EN 1996-1-1:2005/AC

July 2009
Juillet 2009
Juli 2009

Eurocode 6 - Design of masonry structures - Part 1-1: General rules for reinforced and unreinforced masonry structures

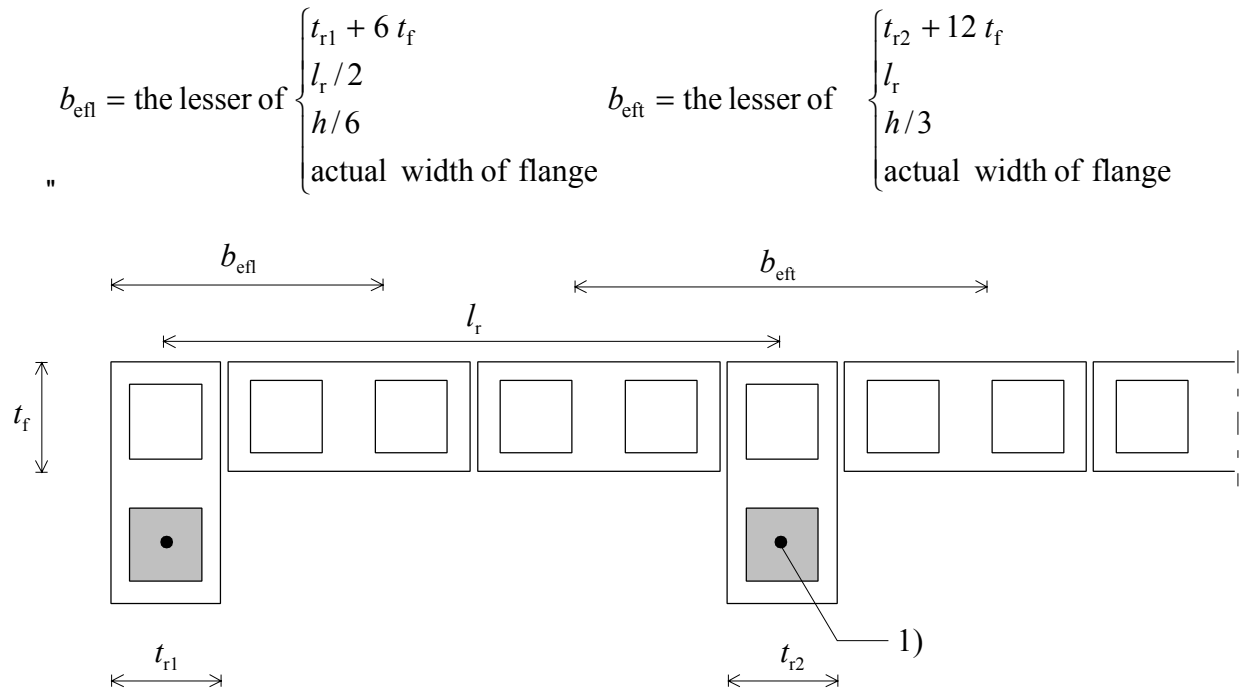
Page 77, paragraph "(5)", equations "(6.24a)" and "(6.24b)", replace "0.4" and "0.3" respectively with "0,4" and "0,3" as follows:

$$M_{Rd} \leq 0,4 f_d b d^2 \quad \text{for Group 1 units other than lightweight aggregate units} \quad (6.24a)$$

$$M_{Rd} \leq 0,3 f_d b d^2 \quad \text{for Group 2, 3 and 4 and Group 1 lightweight aggregate units.} \quad (6.24b)".$$

Figure 6.6 — Effective width of flanges

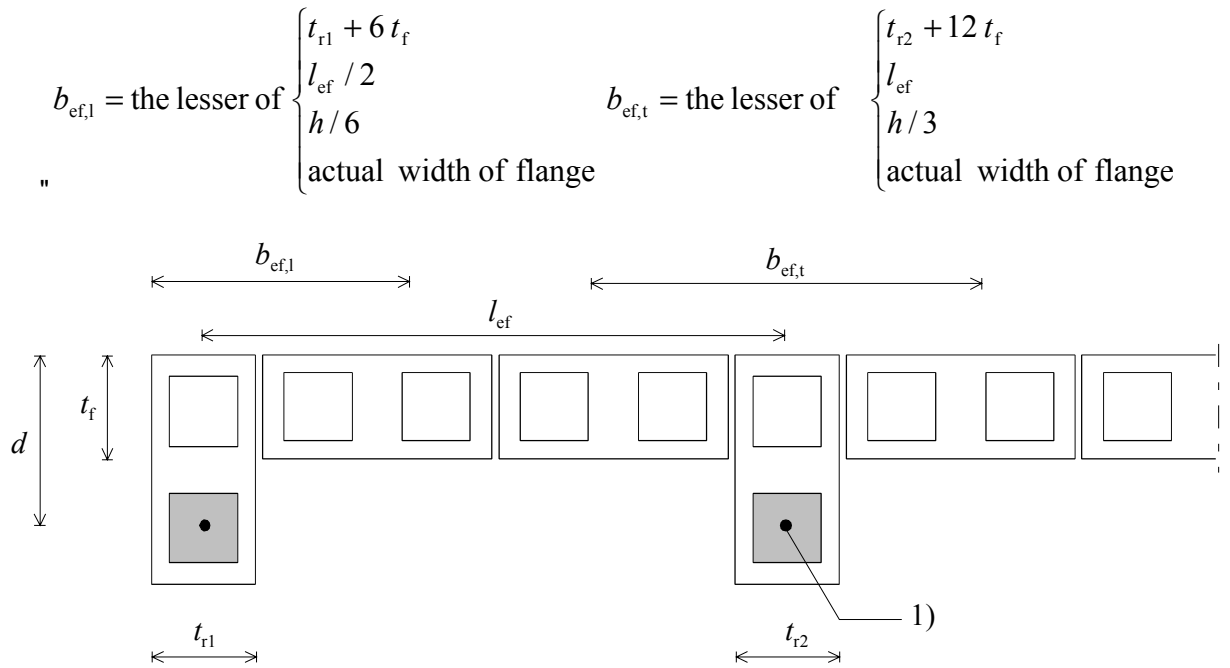
Page 79, paragraph "(1)", replace:

- b_{efl} effective width of a flanged member;
- b_{eft} effective width of a flanged member;
- h clear height of a masonry wall;
- l_r clear distance between lateral restraints;
- t_f thickness of a flange;
- t_{ri} thickness of a rib, i .

- $b_{\text{ef},l}$ effective width of a L-shaped flanged member;
- $b_{\text{ef},t}$ effective width of a T-shaped flanged member;
- d effective depth of the member;
- h clear height of a masonry wall;
- l_{ef} effective distance between lateral restraints;
- t_f thickness of a flange;
- t_{ri} thickness of a rib, *i*."

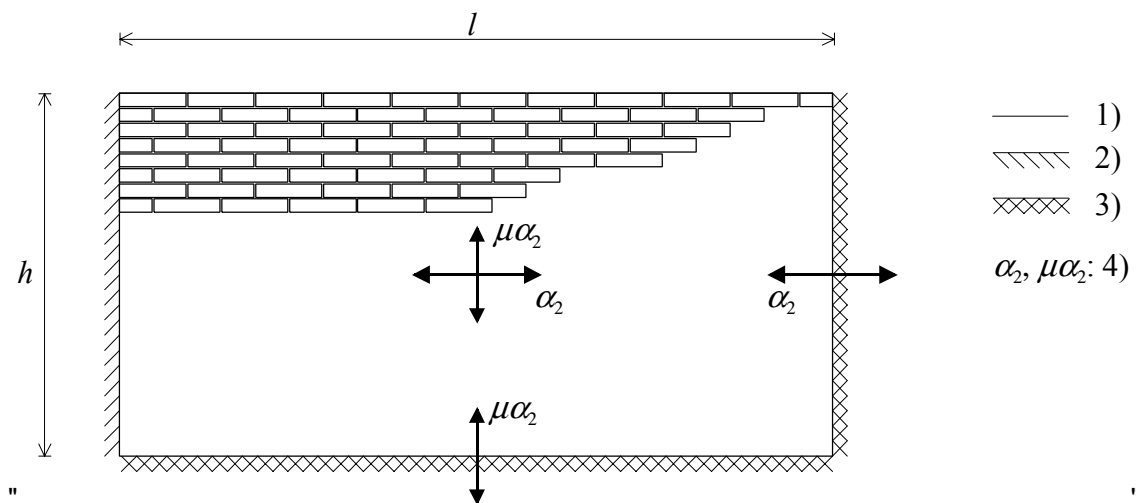
Pages 108 and 109, paragraph "(3)", replace " k_m " with " k_m " in the description of " η " and in equation "(C.2)" as follows:

" η may be obtained experimentally, or it may be taken as $(1 - k_m/4)$,

$$k_m = \frac{n_3 \frac{E_3 I_3}{l_3} + n_4 \frac{E_4 I_4}{l_4}}{n_1 \frac{E_1 I_1}{h_1} + n_2 \frac{E_2 I_2}{h_2}} \leq 2 \quad (\text{C.2})''.$$

Page 112, "Figure E.1", replace the figure with the following one:

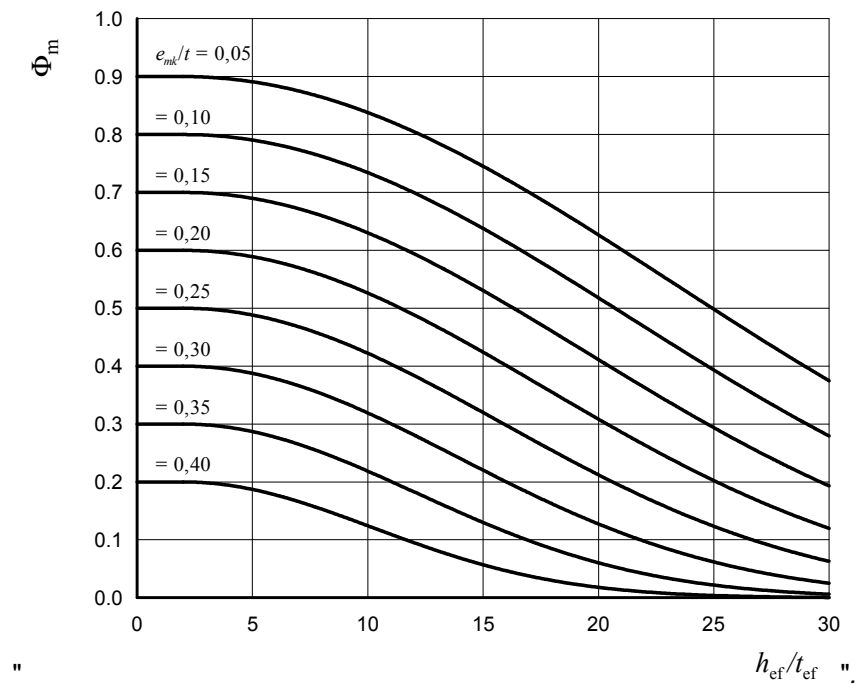
Page 112, "Figure E.1", key "4)", delete " $\alpha_2, \mu\alpha_2$:" as follows:

"4) moment coefficients in the indicated directions".
